**TOWNSHIP OF SOUTH WHITEHALL
LEHIGH COUNTY, PENNSYLVANIA**

PLANNING COMMISSION

PROPOSED FLEX BUILDING 1215 HAUSMAN ROAD
MAJOR SUBDIVISION #2018-106
ATTACHMENTS

TO: PLANNING COMMISSION
FROM: GREGG ADAMS, PLANNER
SUBJECT: PROPOSED FLEX BUILDING 1215 HAUSMAN ROAD
MAJOR SUBDIVISION #2018-106
REQUEST FOR PRELIMINARY/FINAL PLAN REVIEW
DATE: FEBRUARY 15, 2021
COPIES: BOARD OF COMMISSIONERS, R. BICKEL, D. MANHARDT, L. HARRIER,
A. SILVERSTEIN, J. ZATOR, ESQ., J. ALDERFER, ESQ, S. PIDCOCK,
APPLICANT, SUB. FILE #2018-106

SHEET TITLE:
EXISTING FEATURES PLAN

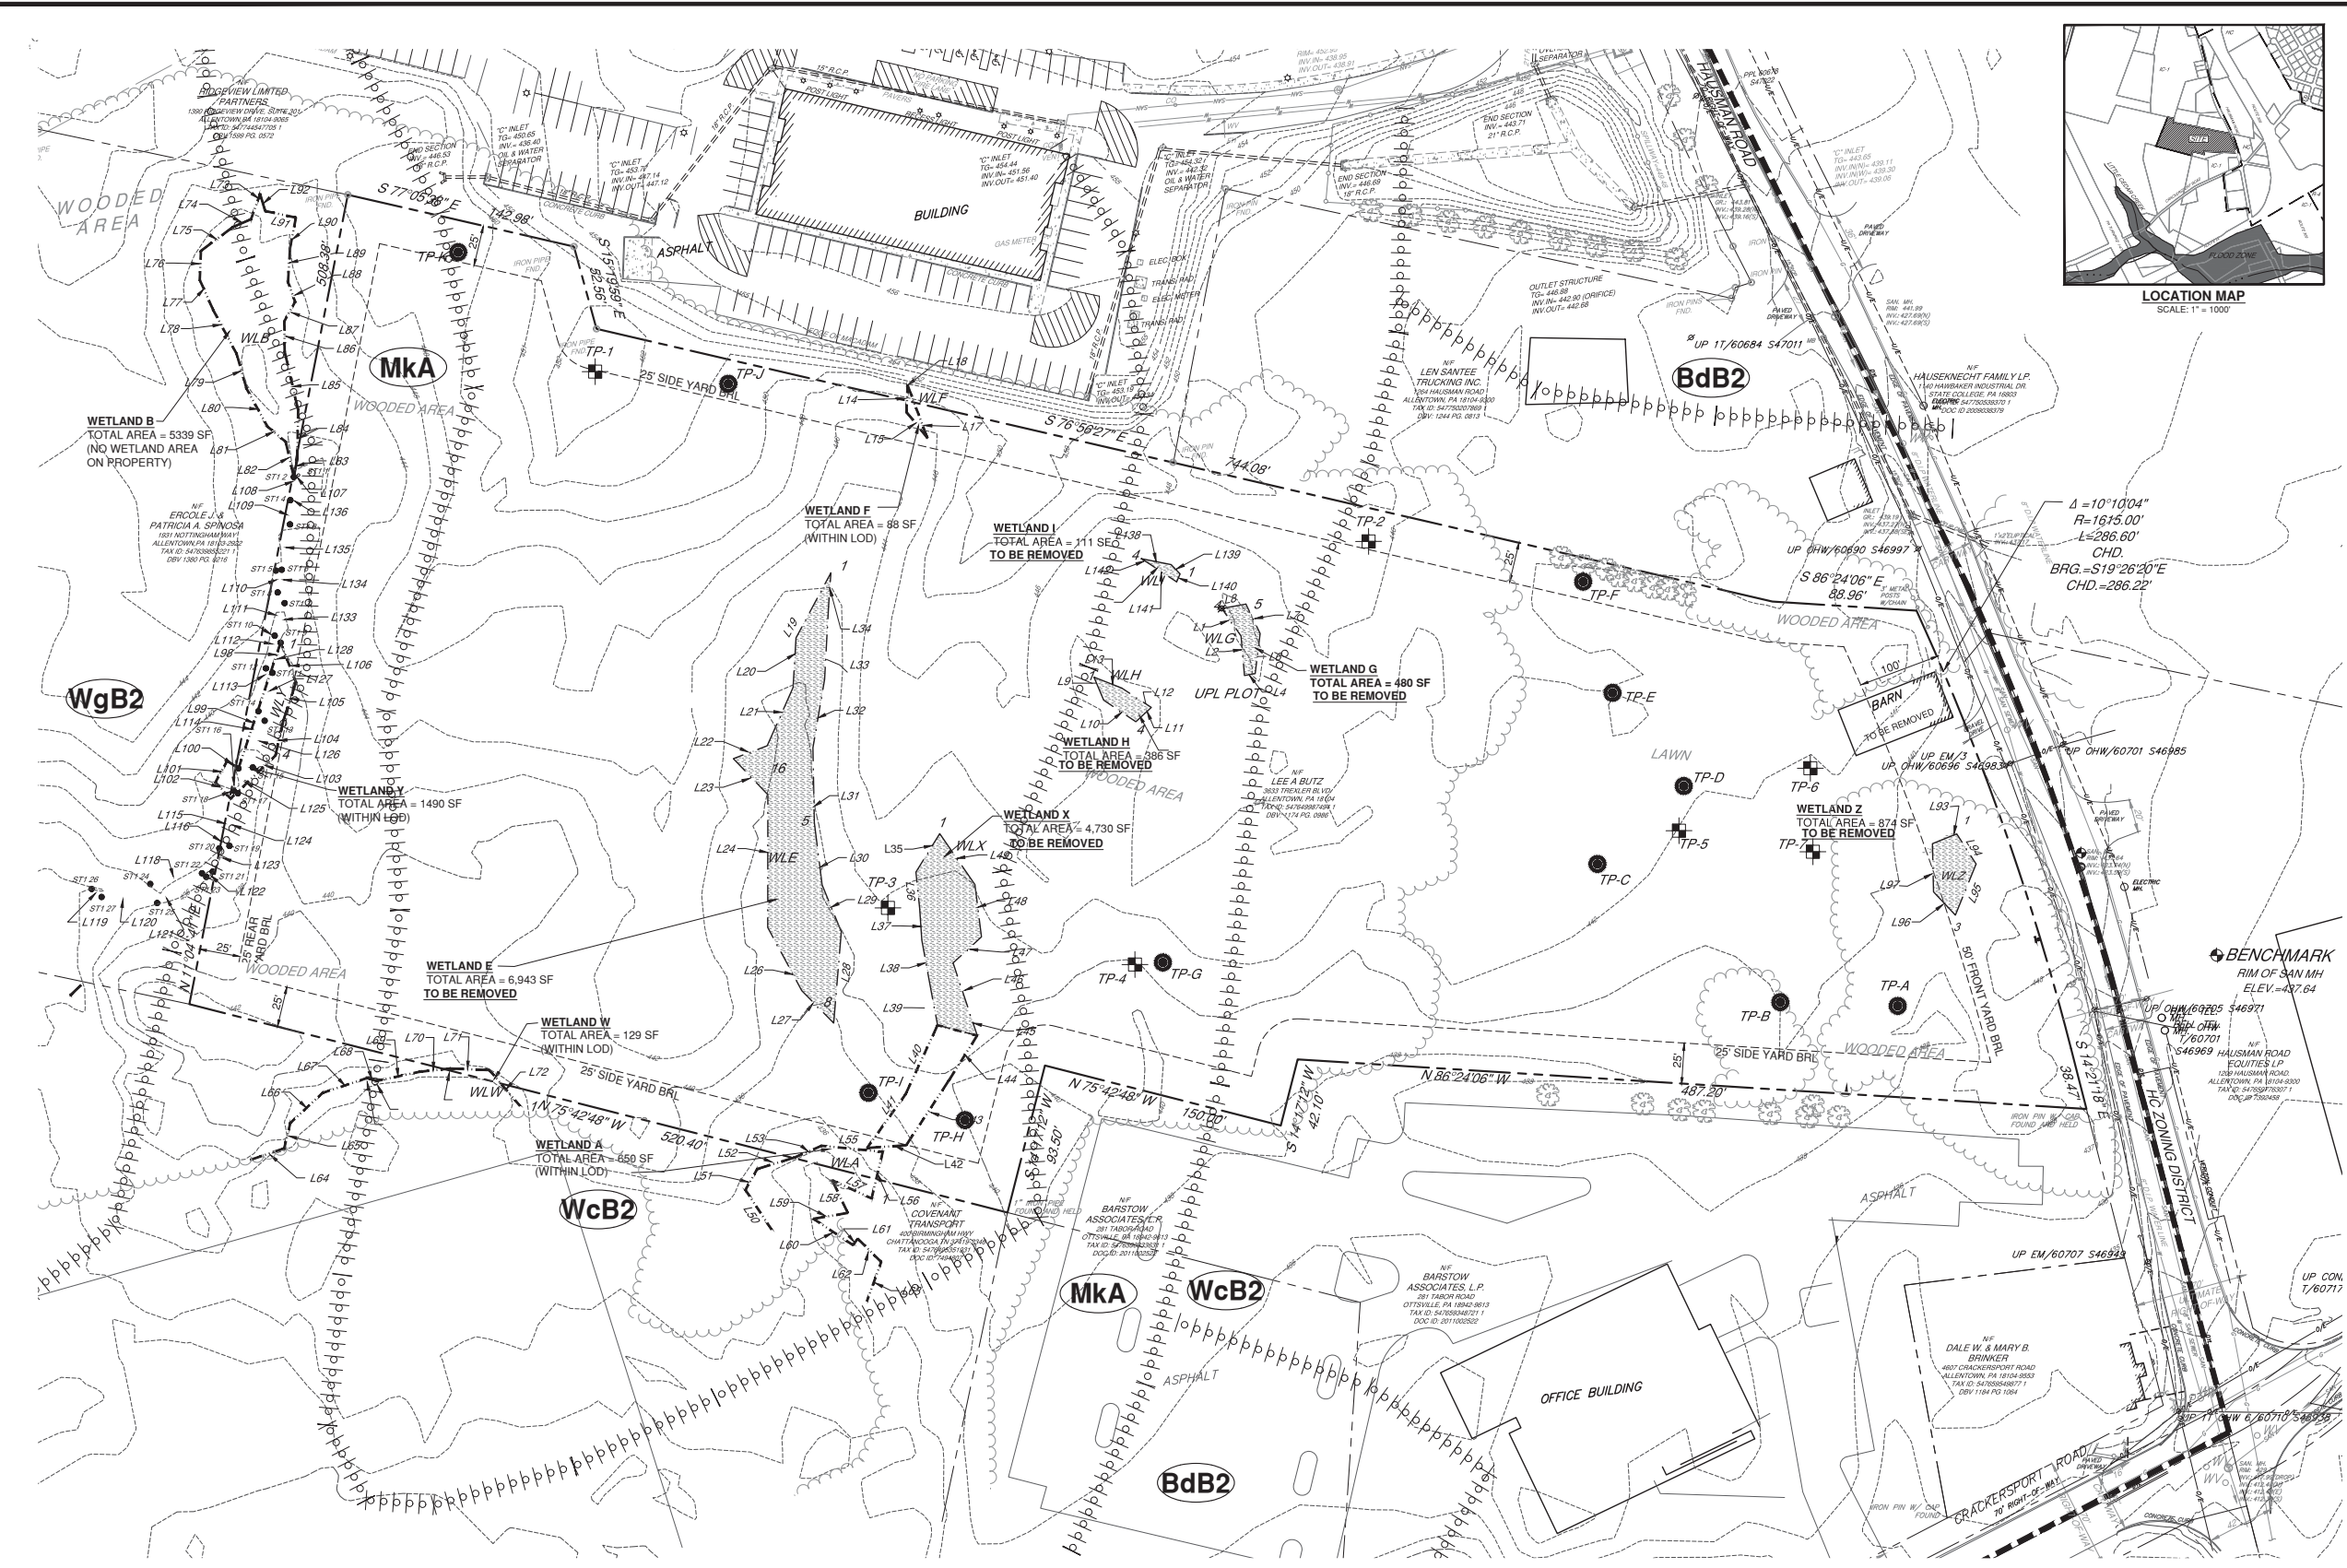
3. *Infiltration testing data has been added to Sheet 3. The locations of all tests shall be clearly depicted on the plan view on that Sheet.*

This comment has not been addressed. The infiltration testing data block previously added to the plans is now mostly overwritten. Test locations have not yet been provided. The implications on site development of the subsurface conditions documented in the test pits will be evaluated once their locations are provided on the plans.

SITE PLAN

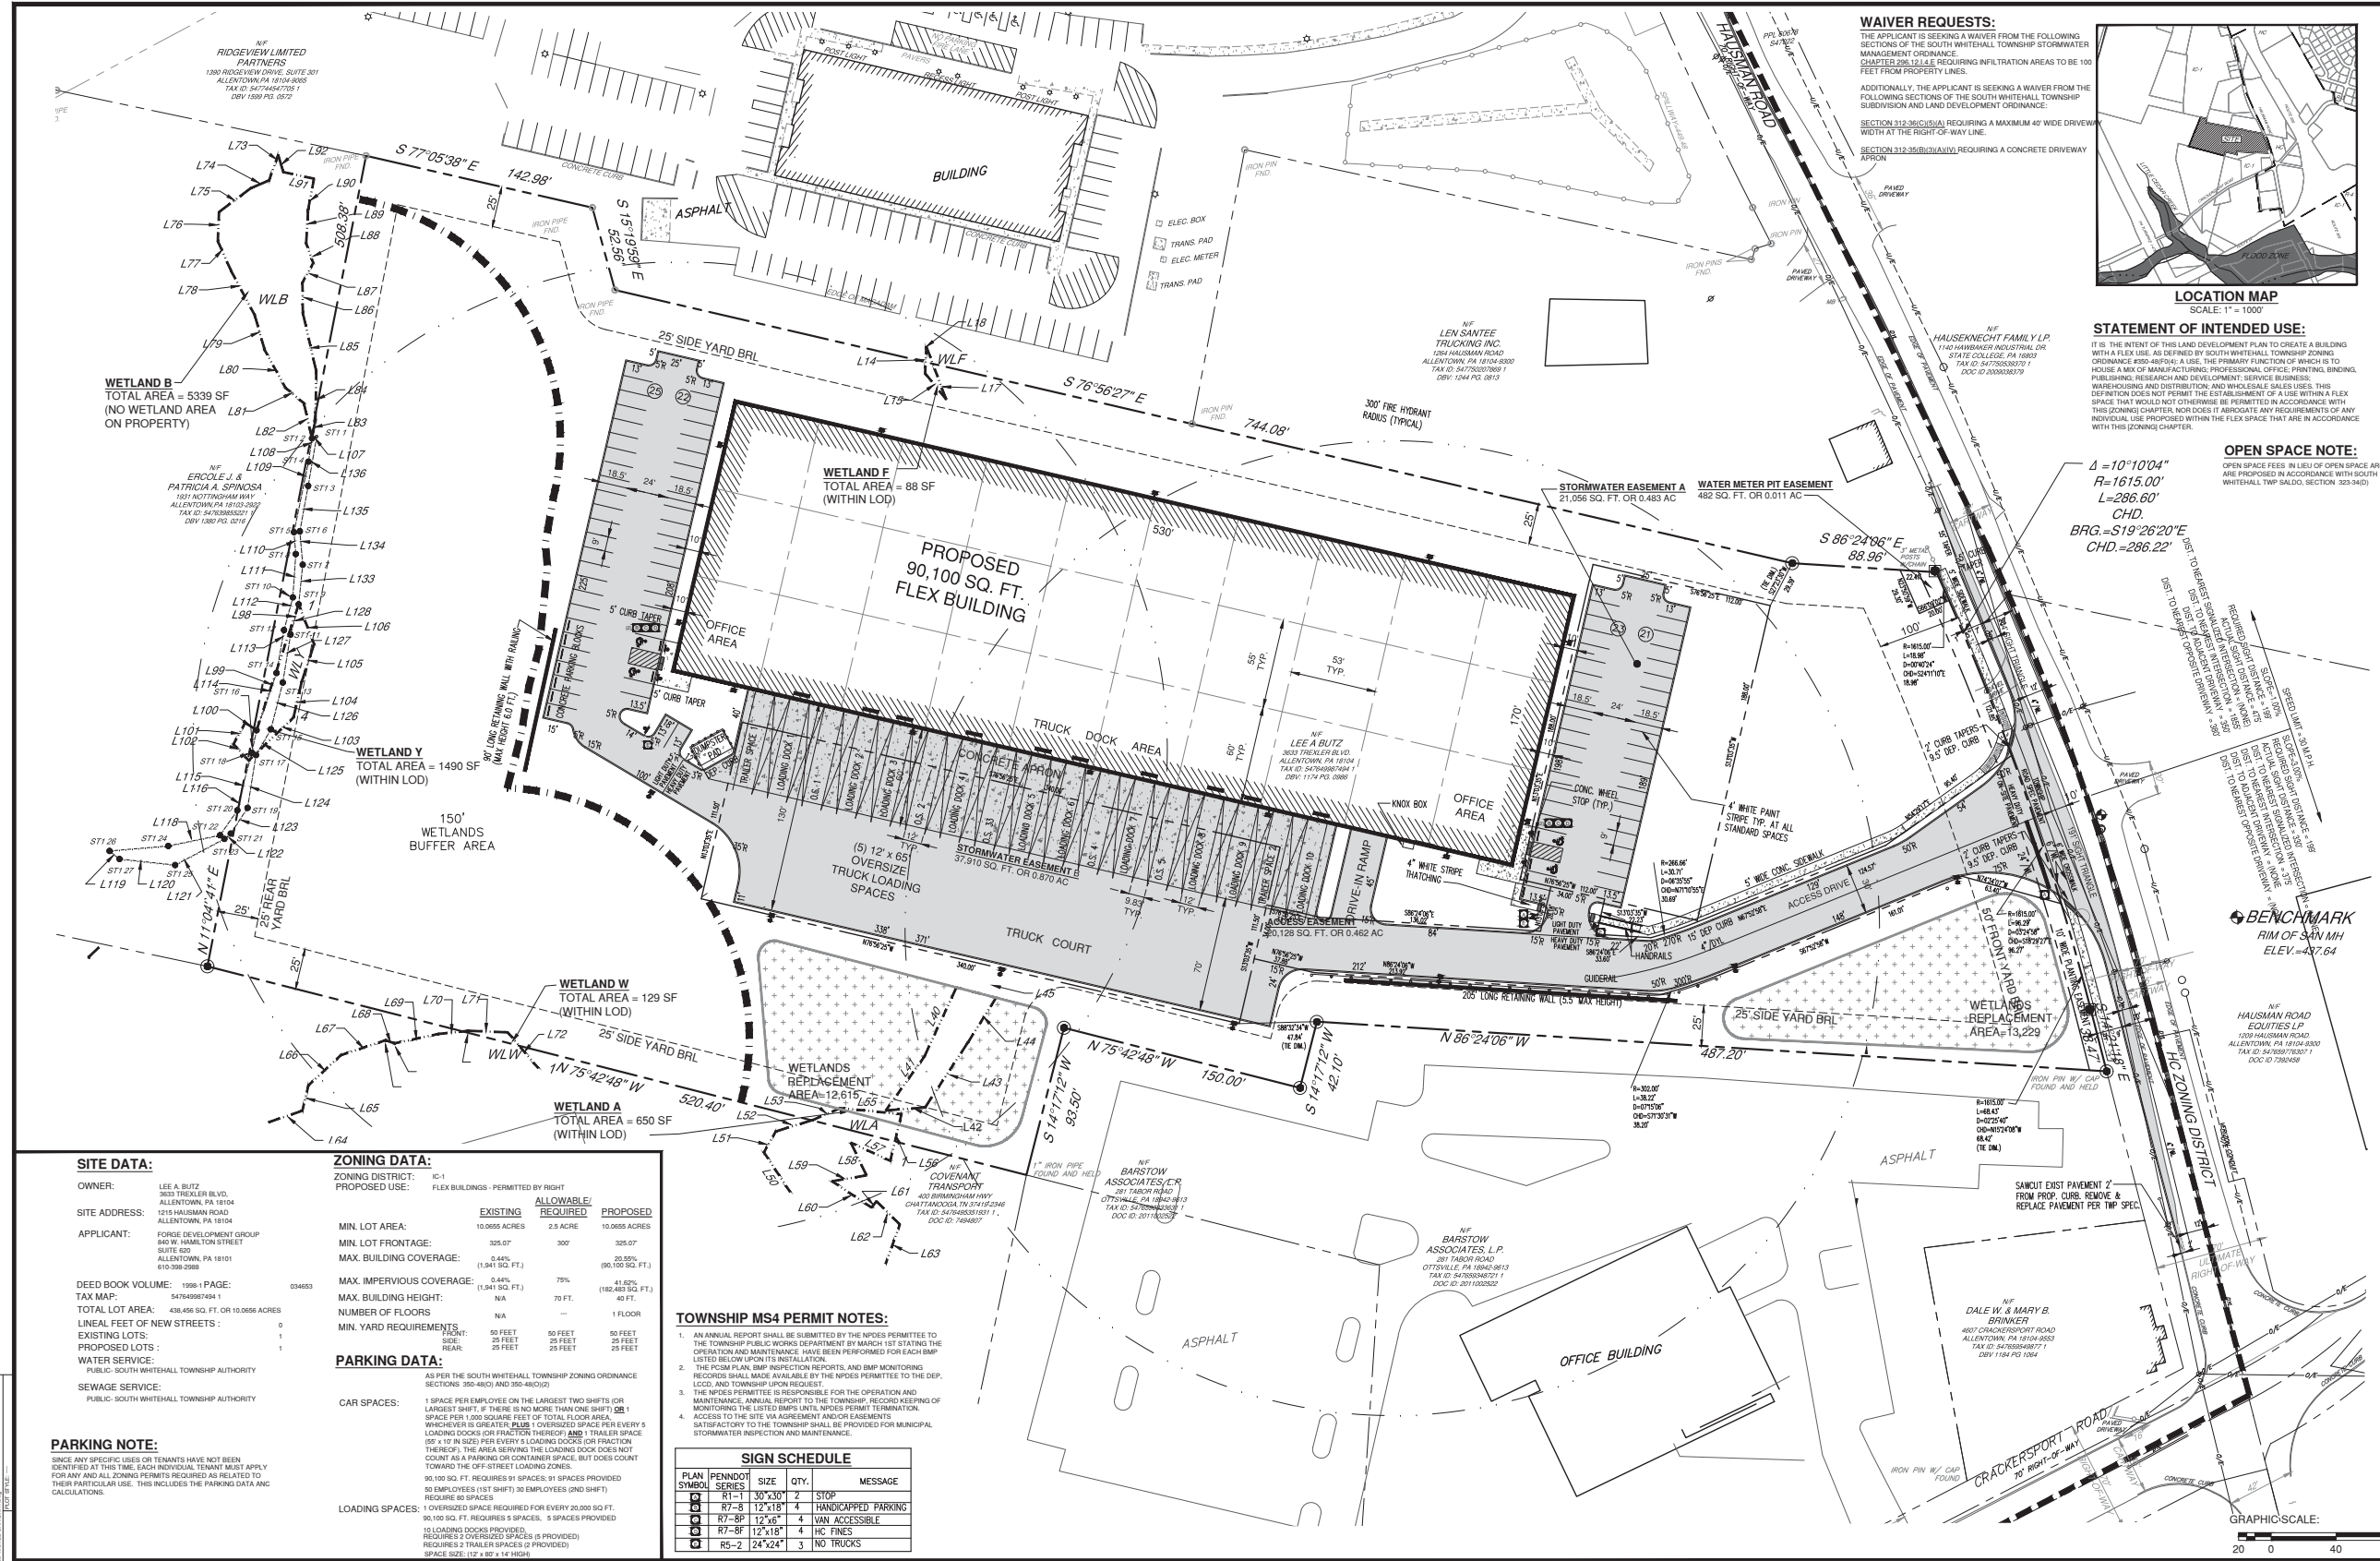
5. *On Sheet 4, the Waiver Request Note states that the applicant is seeking a waiver from Chapter 296.12.1.4.E requiring infiltration areas to be one hundred feet (100') from property lines. The plans indicate that spray heads are designed right along the property line, with the spray to be directed into the subject property and ending at the property line. The Consultant shall clarify how overspray and runoff onto the adjoining property will be prevented or controlled.*

8. Sheet 4 of 26, Site Plan. In the "Statement of Intended Use", an incorrect Zoning Section is noted for Flex Warehouse Definition (a "0" is inserted and should be removed). The plan should reflect the correct Section of "350-48 (f)(4)".
